AGENDA
City of Brookings
Special Council Meeting

In the matter of File No. APP-2-08, an appeal of the Planning Commission's approval of a Detailed Development Plan (DDP) for Southwestern Oregon Community College (SWOCC), on a 10 acre site and a subdivision creating this 10 acre parcel and platting a street from an 80 acre parent parcel; located on the easterly side of Highway 101 approximately 1 mile north of its intersection with Carpenterville Road; Assessor's Map 40-14-00 Tax Lot 2400; zoned Master Plan Development (MPD); Oregon Shores and Catherine Wiley, appellants; CRAG, representative. Criteria used to decide this application can be found in Section 156-appeal to City Council; Section 70-Master Plan Development District (MPD); Section 100-Hazardous Building Site Protection; Section 176.060-Major Partitions and Subdivisions; and Section 172-Public Facilities, of the Brookings Land Development Code (ord.89-0-446). Reviewing the DDP (Detailed Development Plan) using these code sections is required by Chapter 70.110-MPD.

CITY OF BROOKINGS**COUNCIL AGENDA REPORT**

SUBJECT: Appeal of the Detail Development Plan for
Southwest Oregon Community College

FIGURE 5
PROPOSED STORMWATER MANAGEMENT PLAN
SOCC BROOKINGS CAMPUS
BROOKINGS, OREGON

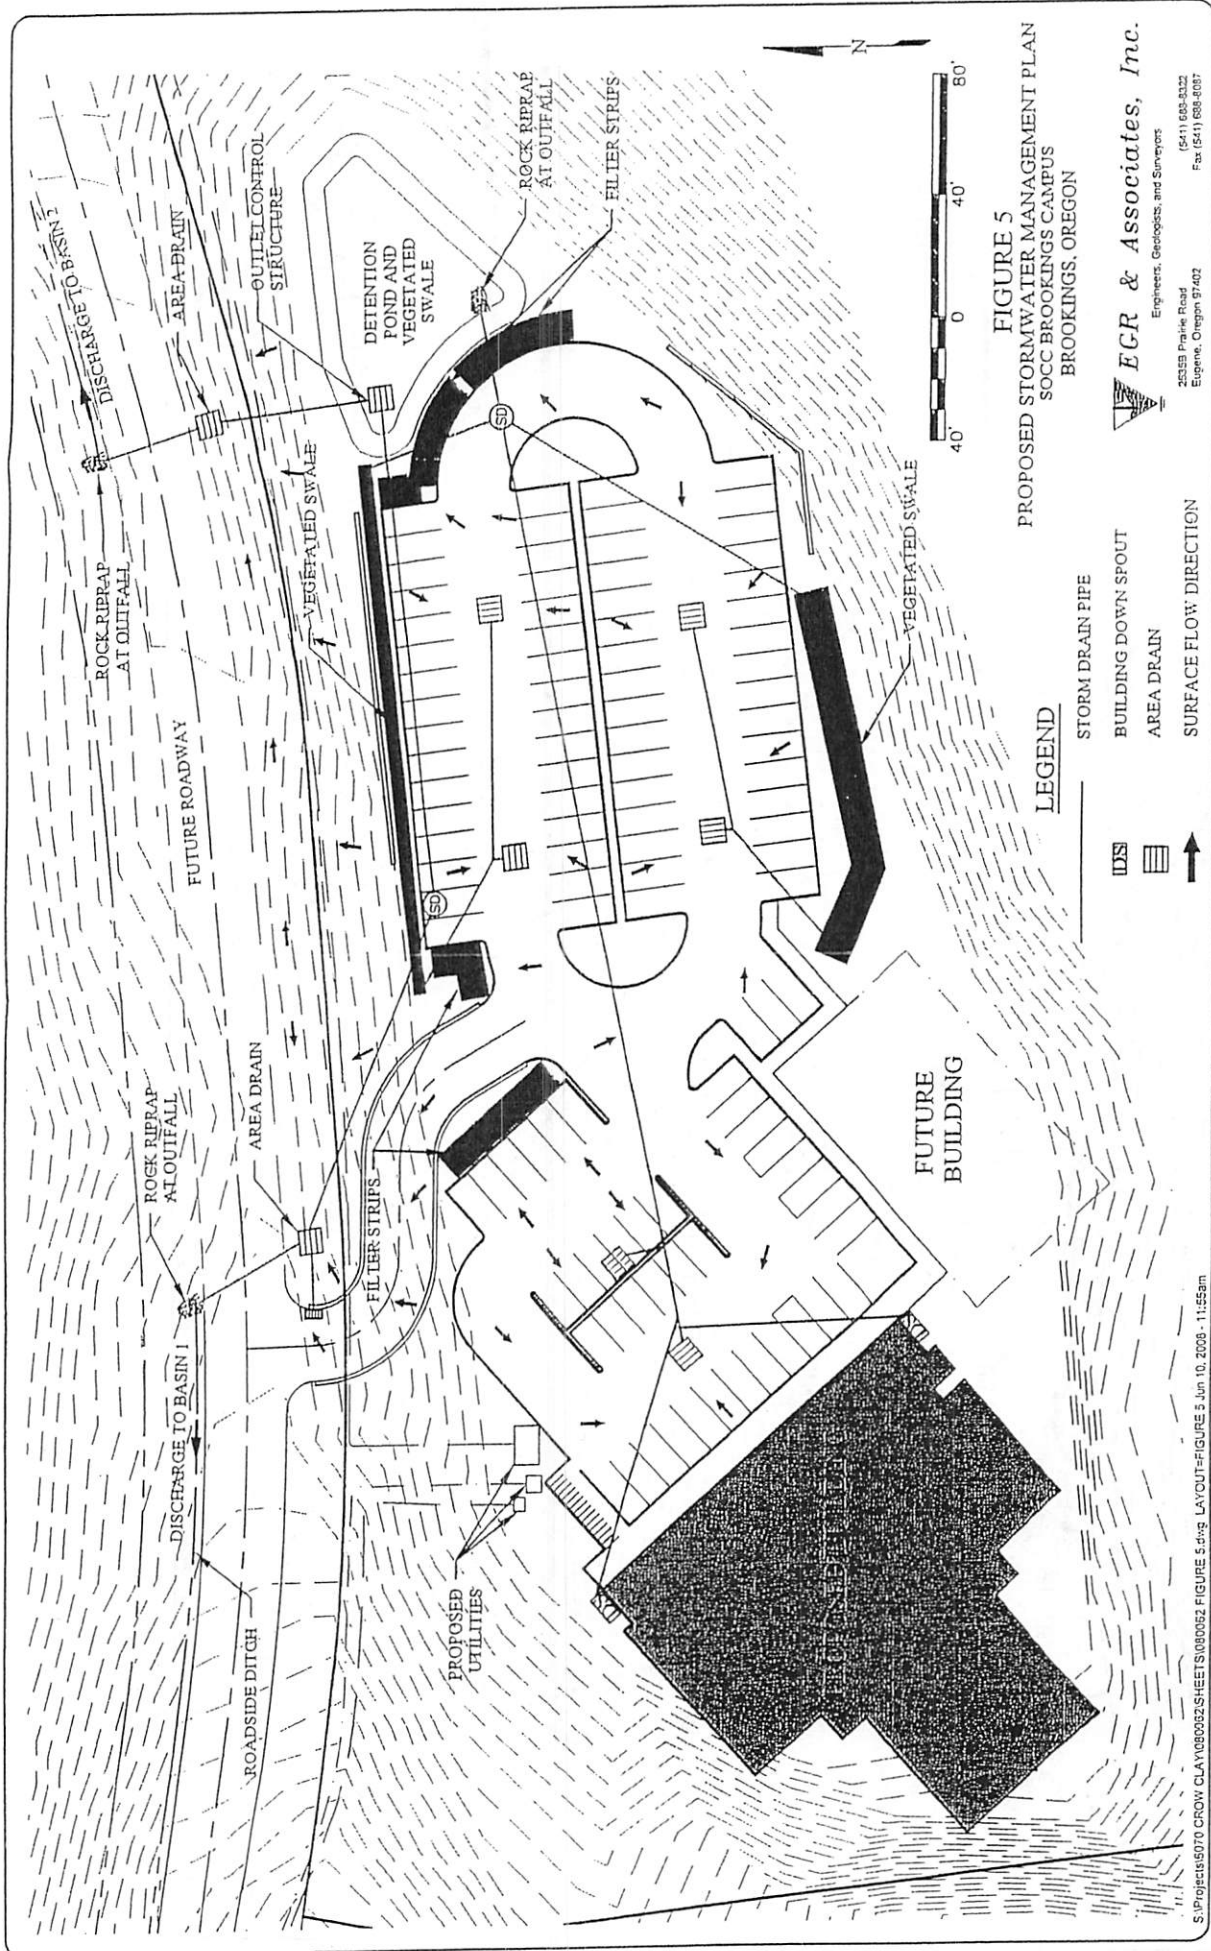
- Storm Water Management - Exhibit B-12 from Crag Law Center states concerns about the adequacy of the Applicant's engineered storm water management plan. The plan, as well as written concerns in Exhibit B-8 submitted by Allan Haddox, Chairman of Rainbow Rock Condo Assoc., has been reviewed and addressed by the City Engineer in page 67 of the original staff report and Exhibit B-15. The City Engineer concludes the plan will adequately deal with storm water and protects the Rainbow Rock Condo's water source and water shed.

The USFWS also reviewed the applicant's proposed Stormwater Management Plan, and in a letter dated July 30, 2008 (Exhibit B-7), stated that the proposed Plan "will adequately protect wetland resources down gradient from the proposed SOCC construction activities."
